CTC AREA OF STUDY – NIST WTC RECOMMENDATIONS

2006/2007 CODE CHANGES SUBMITTED BY OTHER THAN CTC, TRB OR NIBS/MMC

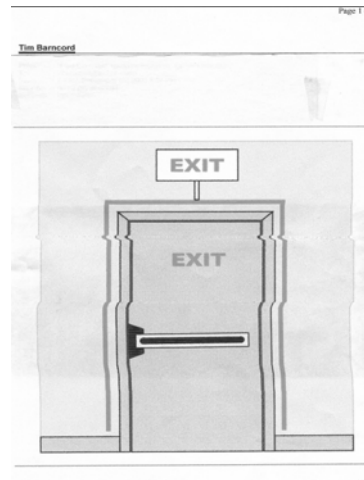
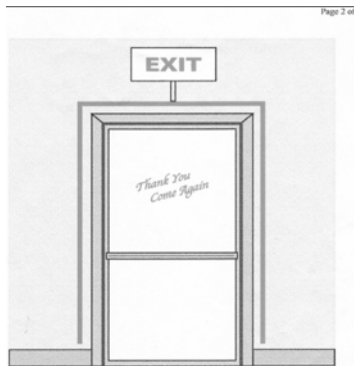
~~4011.5.3~~ **1011.6.3 Power source.** Exit signs and light strips shall be illuminated at all times. To ensure continued illumination for a duration of not less than 90 minutes in case of primary power loss, the sign and light strip illumination means shall be connected to an emergency power system provided from storage batteries, unit equipment or an on-site generator. The installation of the emergency power system shall be in accordance with Section 2702.

Exception: Approved exit sign and light strip illumination means that provide continuous illumination independent of external power sources for a duration of not less than 90 minutes, in case of primary power loss, are not required to be connected to an emergency electrical system.

1011.6.4 Design. Light strips shall have a width of at least 1 inch (25 mm) but not more than 2 inches (51 mm) and be securely attached to the door frame or the wall within 4 inches (102 mm) of the outside edge of the door frame.
